## SERVICE LETTER 260

### CANOE PADDLE / BRACKET UPDATE

<b>Aircraft Makes/Model(s):</b>	<b>Float Model(s):</b>	<b>Compliance:</b> Optional	<b>By:</b> MAS
Multiple	2100A, 2100S, 2350A, 2350S, 3000A, 3000S, 3450A, 3450S, 6100A, 6100S, 8000A, 8000S, 8750A, 8750S	<b>Part Number:</b> 1012485	<b>Approved:</b> DRH
		<b>Date:</b> 1/18/2024	<b>Revision:</b> A

**Figure 1 - 2100 Floats**

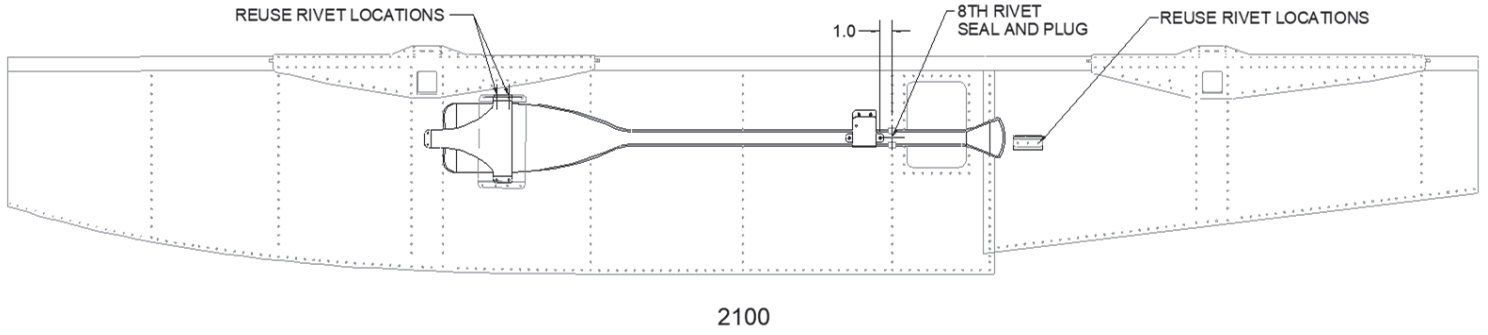
1. Optional: Prior to installation items 1, 2, and 3 may be painted to match float colors as needed.
2. Position and prepare aircraft for safe maintenance.
3. Remove current canoe paddle and mounting brackets.
4. Install items 1, 2, and 3 per appropriate float figures below.
5. Plug the existing spring clip bolt hole using, screw, nut & washer, (washer under the nut).
6. For kits -02, -03, and -04 install new paddle.
  - a. For kit -01 re-install existing paddle.
